##### Group of Experts on Road Signs and Signals

## Report of the Group of Experts on Road Signs and Signals on its Eighth session

### A sign-by-sign assessment by the Group of Experts

**B, 5 “PRIORITY FOR ONCOMING TRAFFIC”**

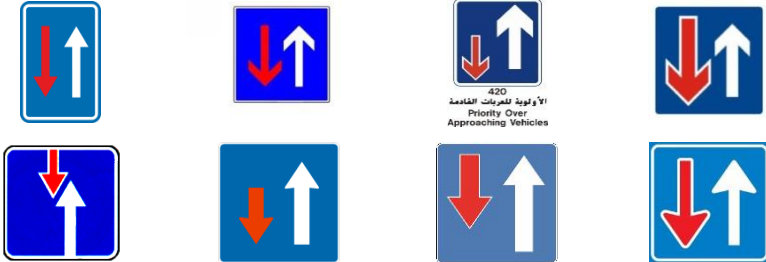
The Group noted that some countries do not use the arrows (ie length, width, positioning) as they appear in the Convention. The Group recommended that the arrowheads in the symbol used in Annex 3 of the Convention be enlarged, and that the signs of countries be in line with the revised symbol. The Group also recommended that the following additional words be inserted at the start of the article related to sign B, 5: “The sign indicating priority for oncoming traffic shall be sign B, 5.”

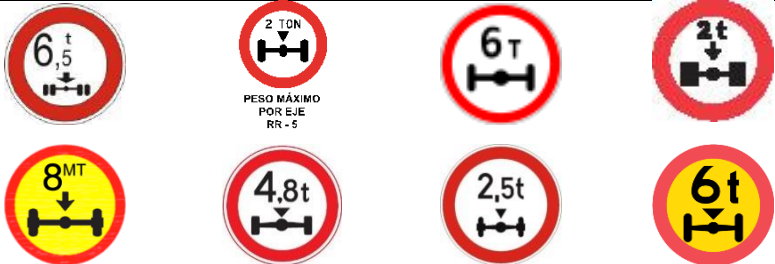
The Group noted that one country used a sign with the image of a goods vehicle, and believe that this was a change of the essential characteristics of the symbol. The Group also noted that there was a difference in the casing of the symbol “T” (ie some countries use lower casing “t”) as well as its positioning within the sign, and also that some countries used commas and period marks. The Group believed that the symbol in the Convention should be modified from upper to lower casing (“t”) and that the positioning of the symbol “t” should appear where it currently appears in the Convention.

The Group also believed, that where a comma or period mark is used, that the second digit should be two-thirds the size of the first digit, and that the lower casing “t” should appear immediately after the second digit and at the same level, and be proportionately visible. If a fraction is required, the Group believed that it should be to the nearest tenth (ie 3.5t, 7.8t). If it is an integer (i.e. 7.00t), it should appear without any zeros or period marks (ie 7t).

*Kuwait to rectify its sign.*

**C, 8 “NO ENTRY FOR VEHICLES HAVING A MASS EXCEEDING ... TONNES ON ONE AXLE”**

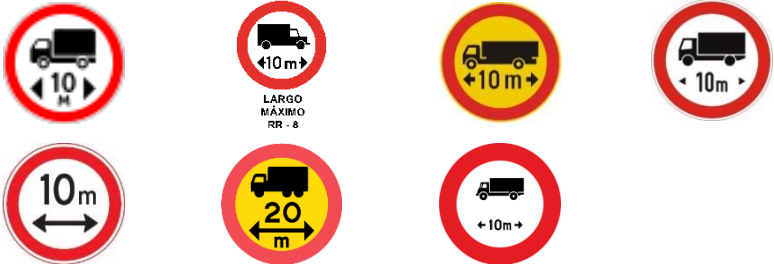
The Group noted that there was a difference in the casing of the symbol “T” (ie some countries use lower casing “t”), its positioning within the sign, and also that some countries used commas and period marks. The Group also noted differences in the arrowheads and axles. The Group believed that the symbol in the Convention should be modified from upper to lower casing (“t”) and that the positioning of the symbol “t” should appear where it currently appears in the Convention. The group also believed that the arrow should be deleted, replaced by one arrowhead and that the number used for the first digit in the Convention symbol should be larger.

Finally, the Group believed, that where a comma or period mark is used, that the second digit should be two-thirds the size of the first digit, and that the lower casing “t” should appear immediately after the second digit and at the same level, and be proportionately visible. If a fraction is required, the Group believed that it should be to the nearest tenth (ie 3.5t, 7.8t). If it is an integer (ie 7.00t), it should appear without any zeros or period marks (ie 7t).

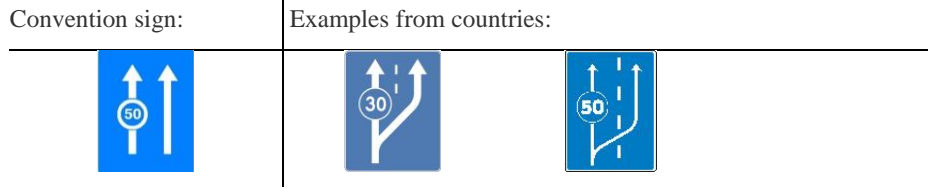
Many countries use road markings (broken line) on this sign. The Group recommended the symbols on this sign not to include road markings ie., broken lines, as the arrows indicate the “lanes”.

The Group recommended that for the E, 1 a sign the sign D, 7 is used with a white rim.

**E, 1 b “COMPULSORY MINIMUM SPEED APPLYING TO ONE LANE”**

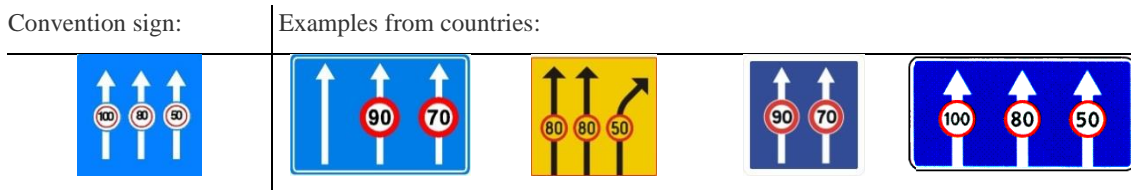
Albania, Croatia and Greece wrongly used examples for E, 1 a instead of E, 1 b.

Many countries use road markings (broken line) on this sign. The Group recommended the symbols on this sign not to include road markings ie., broken lines as the arrows indicate the “lanes”.

The Group recommended that for the E, 1 b sign the sign D, 7 is used with a white rim.

**E, 1 c “SPEED LIMITS APPLYING TO DIFFERENT LANES”**

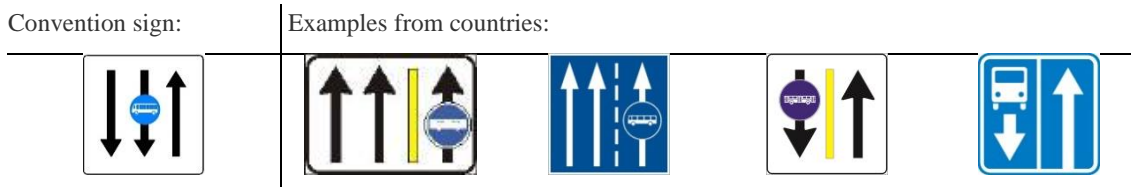
Azerbaijan used a wrong example for E, 1 c sign (truck entry prohibition sign instead of speed limit sign).

The Group recommended that the E, 1 c sign is improved by placing the sign C, 14 on the arrows and adding a white rim.

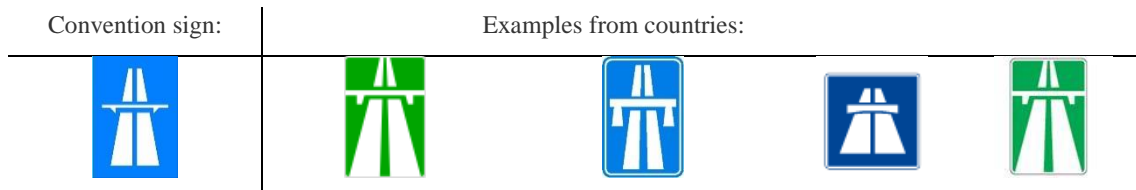
All the signs are in conformity with the Convention as they are examples. However, the Convention Section E, subsection II, point 4 is not very clear. The Group believed that the Convention sign, as reproduced in Annex 3 should not include the right and left broken line indicating the road markings. The use of road markings between the lanes e.g. indicated by broken lines should be optional.

The E, 4 sign should be placed immediately after E, 2 b sign.
